Enclosure 1

COLA will be revised as shown in this enclosure. These mark-ups are based on COLA Rev. 6 and replace those provided in RAI 03.07.01-29, Supplement 1 in their entirety.

3H.10 STP 3 & 4 Resolution of Issues with Subtraction Method of Analysis Identified by DNFSB

Figure 3H.6-28: Broadened FRS in E-W (X) Direction at the Top of UHS Basin Walls (Elevation 97.5 ft MSL)

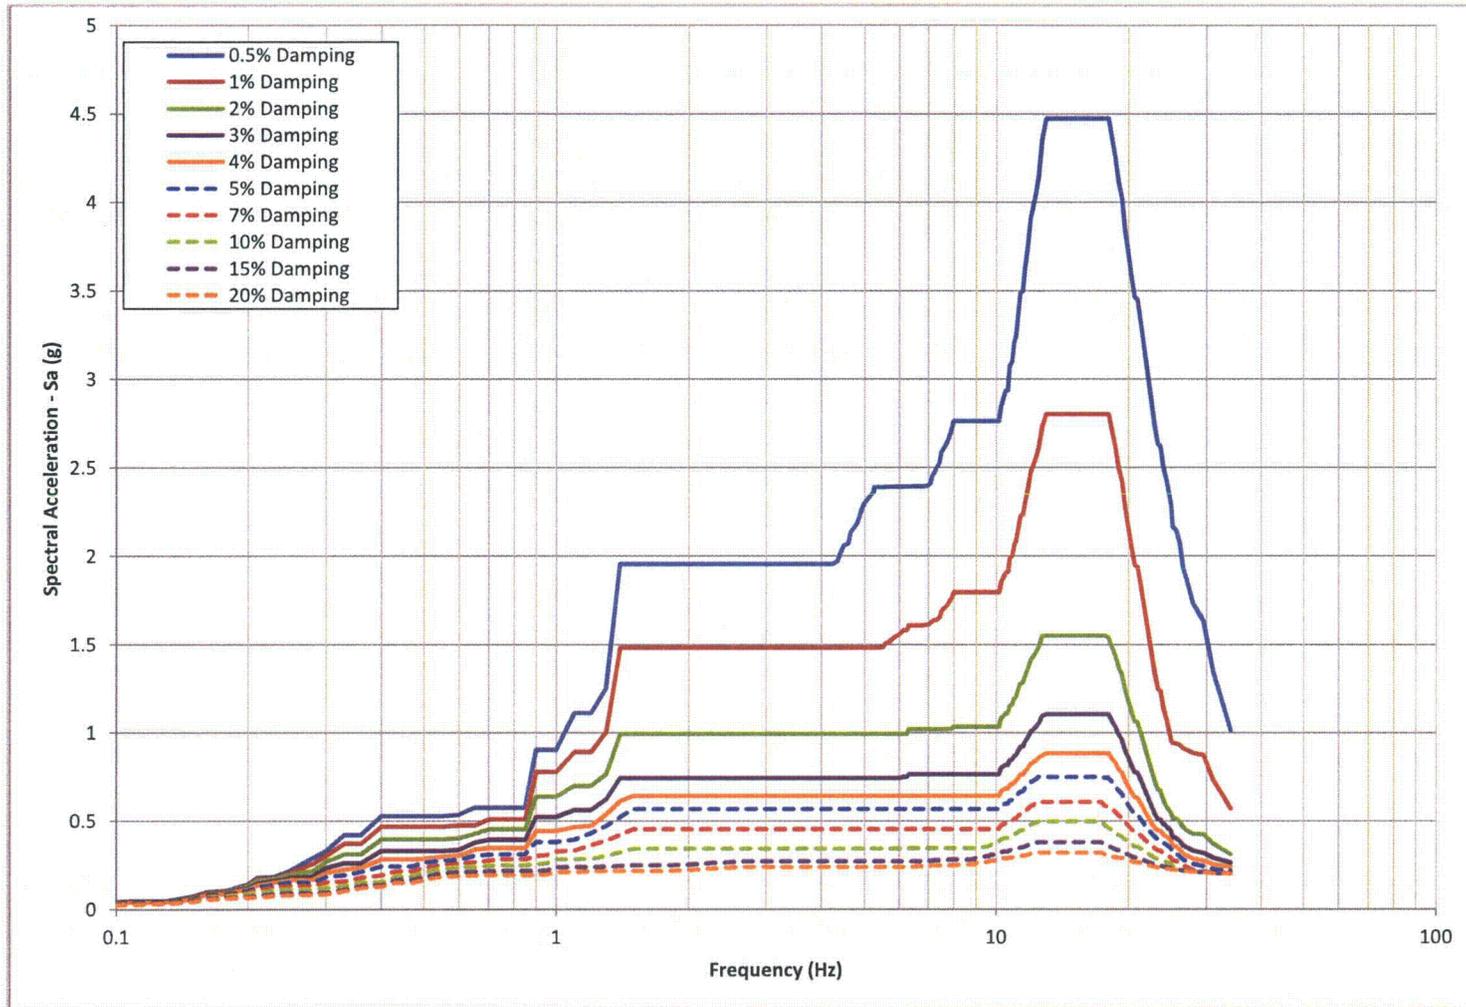
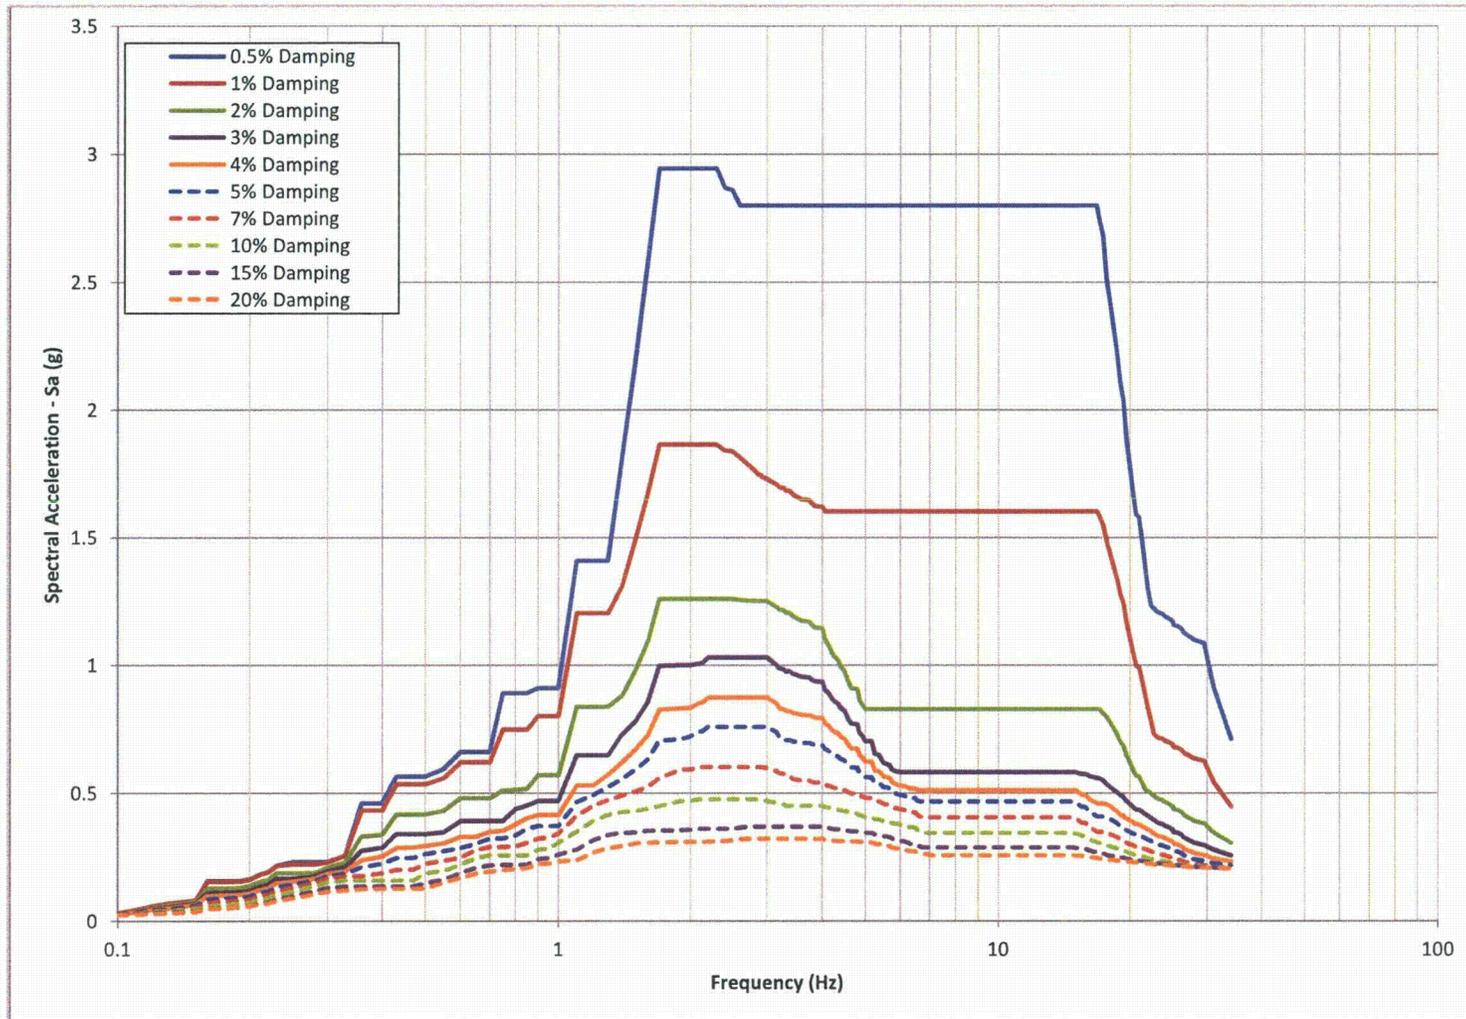
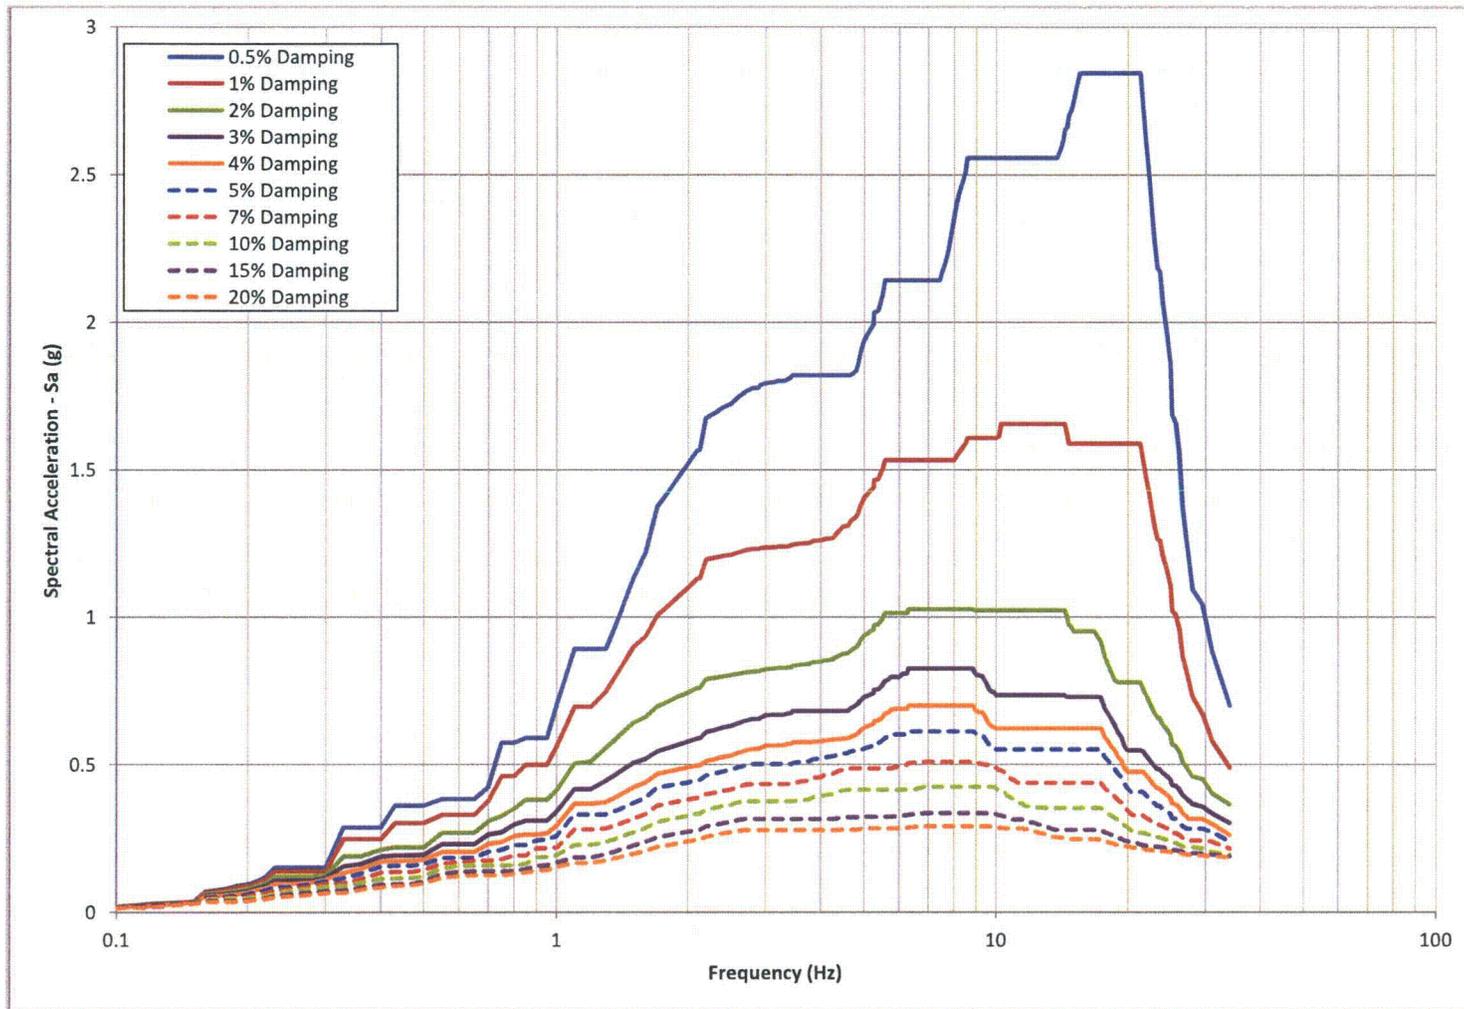
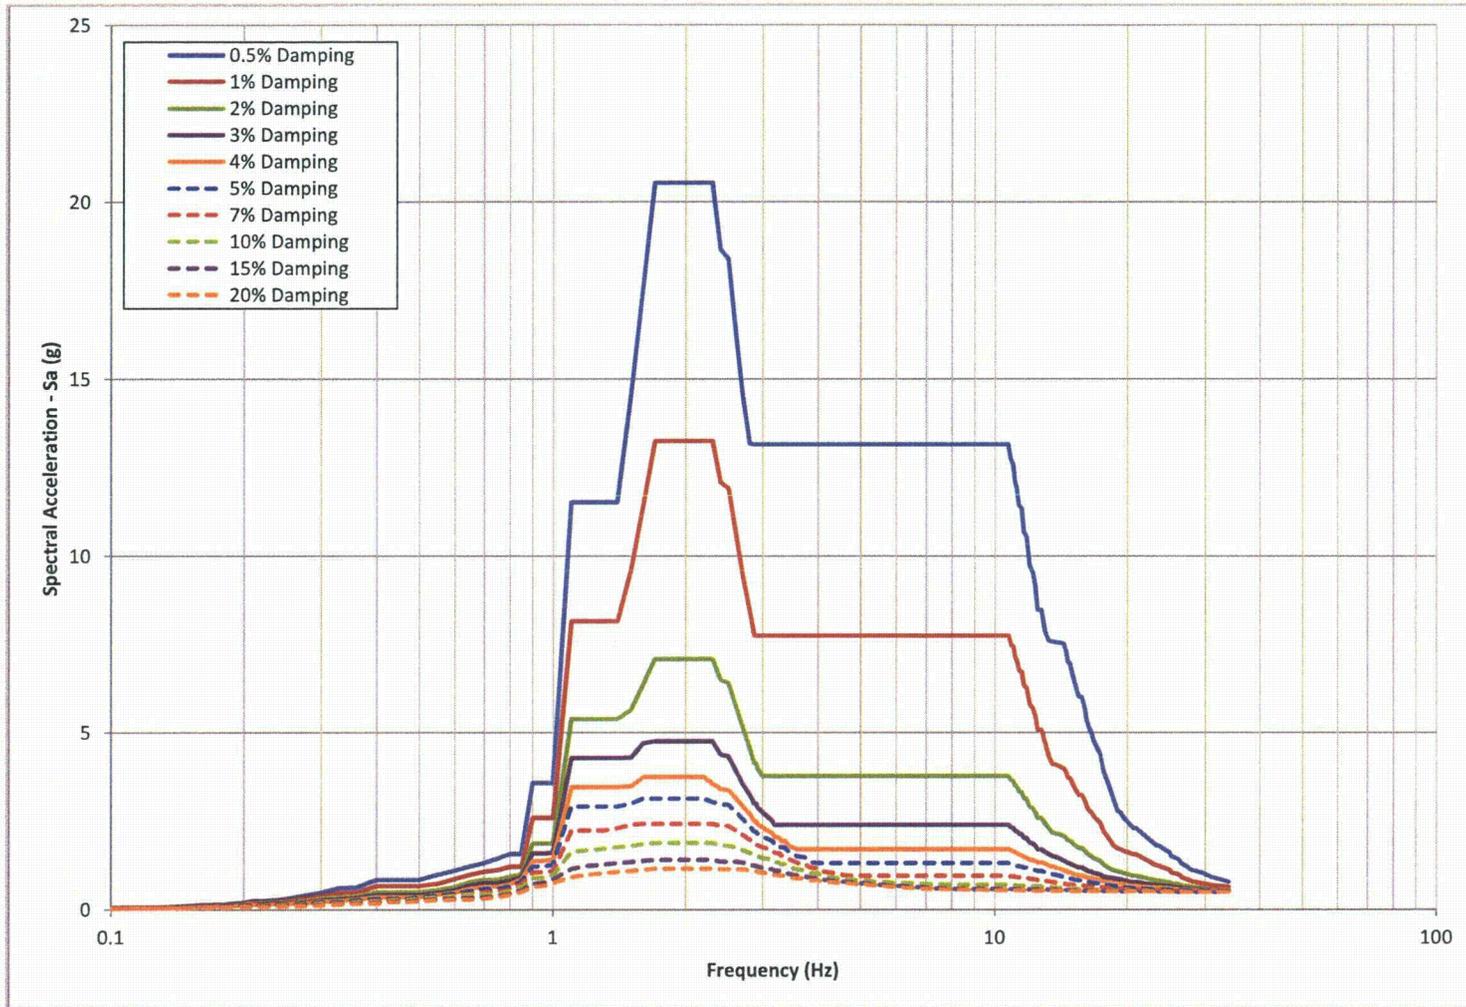
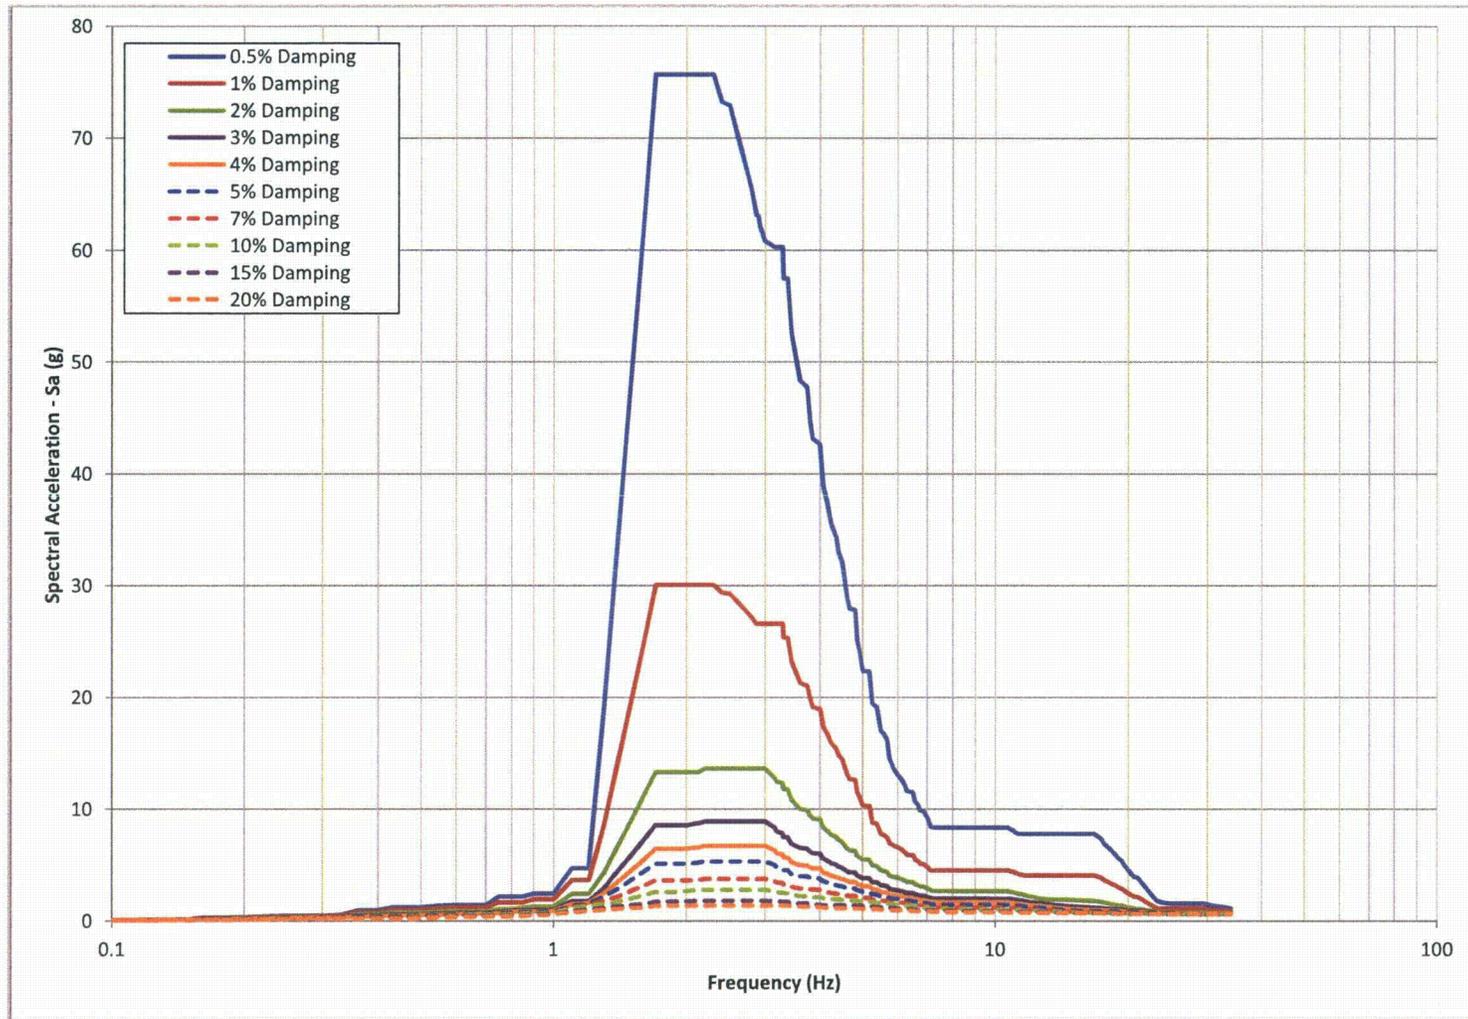
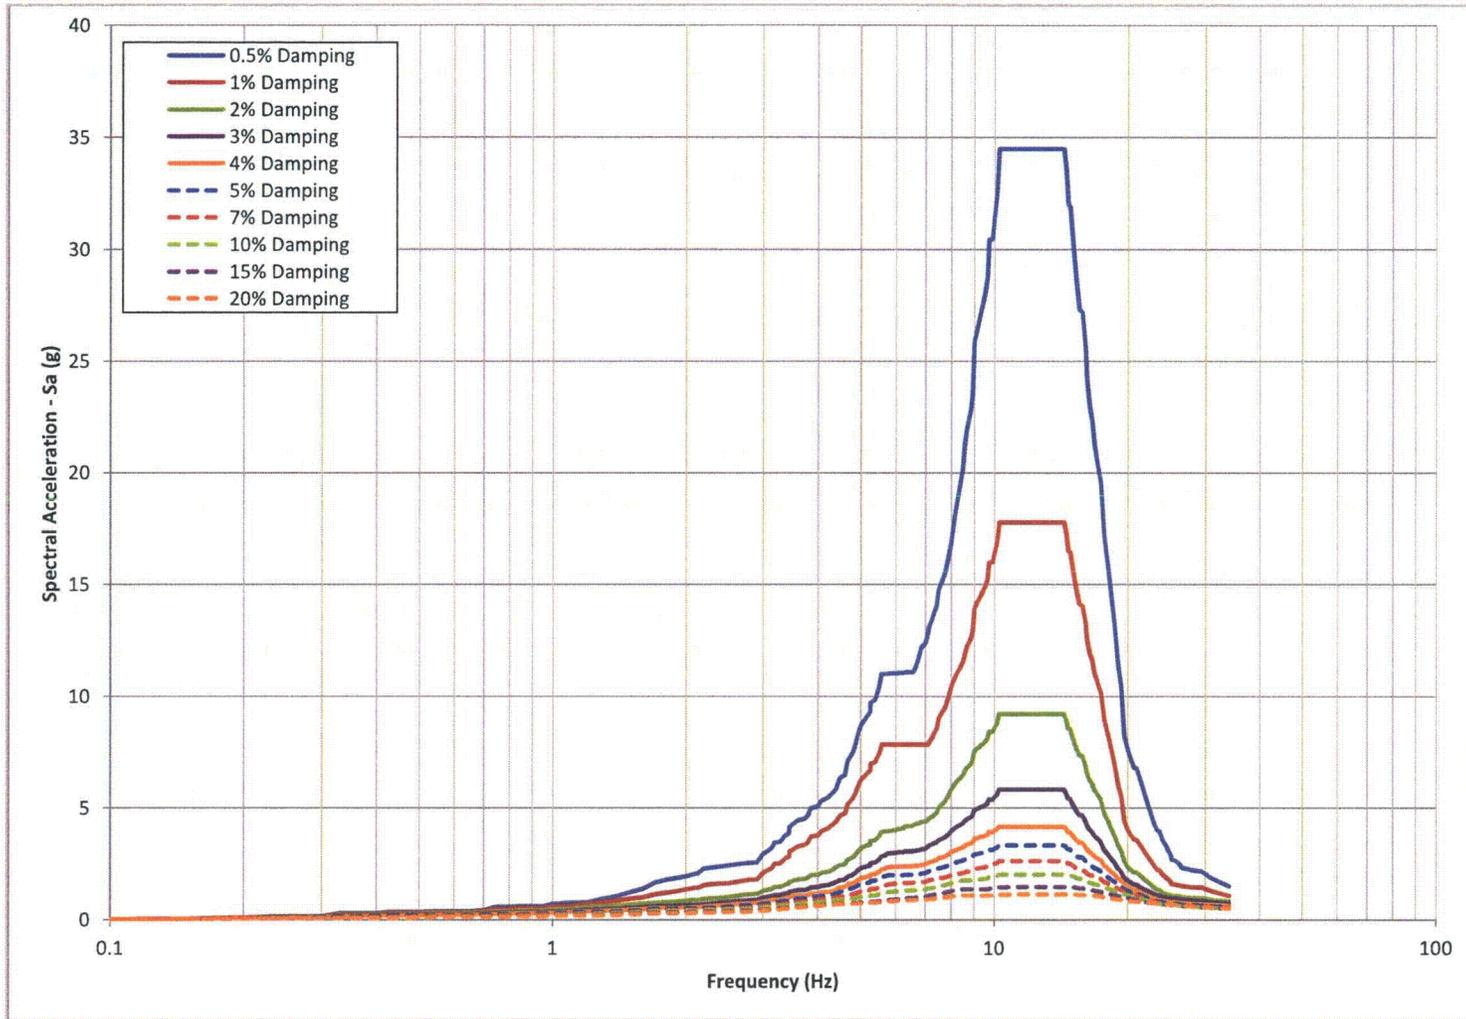
Based on the results of the above refined SSI analyses, and additional structural mesh sensitivity analyses, envelope modification factors were determined for increase of the following in-structure response spectra obtained from the SSI analyses described in Section 3H.6.5.2.4 and 3H.6.5.2.4.1. were modified by multiplying them with the modification factors shown in Table 3H.6-17. Then, the results of the full and empty basin analyses were enveloped.

- Vertical direction spectra at the center of the Pump House Roof
- Vertical direction spectra at the center of the Pump House Operating Floor
- Vertical direction spectra of the Cooling Tower Walls
- Out-of-plane horizontal spectra of the Basin Walls

In response to issues with the subtraction method of analysis identified by the Defense Nuclear Facilities Board (DNFSB) discussed in Section 3H.10, the SSI analysis for the upper bound in-situ soil case was repeated for both full and empty basin cases using the modified subtraction method of analysis. Also, in these analyses the groundwater table was changed to 6 ft below grade. Based on comparison of the resulting response spectra from these analyses to those from the subtraction method of analysis additional modification factors were determined for increase of in-structure response spectra from the subtraction method of analysis to account for the effect of using the modified subtraction method. The product of these modification factors and those described in Section 3H.6.5.2.4.2 as shown in Table 3H.6-17 were used to increase the in-structure response spectra described in Sections 3H.6.5.2.4 and 3H.6.5.2.4.1. Then, the results of the full and empty basin analyses were enveloped.

The final in-structure response spectra are shown in Figures 3H.6-16 through 3H.6-39.

The final in-structure response spectra are shown in Figures 3H.6-16 through 3H.6-39.
